UNLESS OTHERWISE SPECIFIED DIMENSIONS ARE IN INCHES							LIGO CALIFORNIA INSTITUTE OF TECHNOLOGY MASSACHUSETTS INSTITUTE OF TECHNOLOGY			
		TOLERANCES: FRACTIONAL ± 1/16 ANGULAR ± .25° ANGULAR MACH ± BEND ± TWO PLACE DECIMAL ± .01			THREE PLACE DECIMAL ± .005 FINISHED SURFACE RMS 63 BREAK CORNERS IN: .015 OUT: .015 REMOVE ALL BURRS					PIN, PIVOT		
		MATERIAL: 300 series S. STL.	HEAT TREAT: /	FINISH: /								
DWG. NO.	DESCRIPTION	USED ON: XXX	NEXT ASS'Y: XXX	REV	DESCRIPTION	DCN NUMBER	APPR'D	CHECK	DRWN	DATE	CAD FILE D980582-C	SIZE DWG. NO. B D980582-C
REFERENCE DRAWINGS				ISSUE DESCRIPTION						SCALE 1 : 1 SHEET 1 OF 1

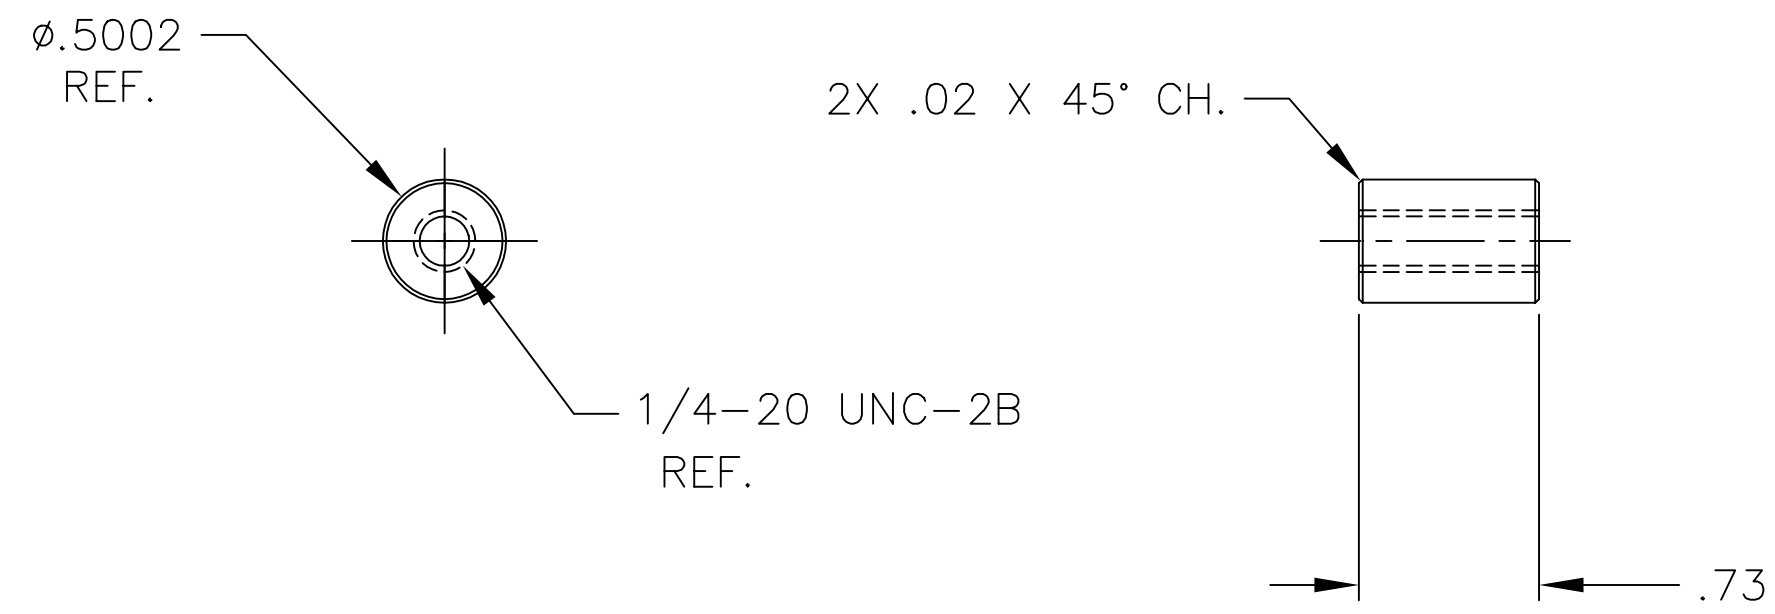
~~Liquid contaminants/Machining Lubricants~~
 Liquids containing hydrocarbons or other contaminants, other than the machining fluids specified herein, shall not be allowed to come into contact with suspension material at any time. All machining fluids shall be water soluble and free of sulfur, chlorine and silicone; such as Cincinnati Milacron's Cimtech 410 (stainless steel).

Identification_Serial Number
 A serial number shall be etched, or scribed on the part see note drawing note.
Serial Number Format
 The Serial number shall be of the format: D99xxxx-x-001

Example: D990021-A-001
 The drawing number, The revision number, ~~The sequential part number~~
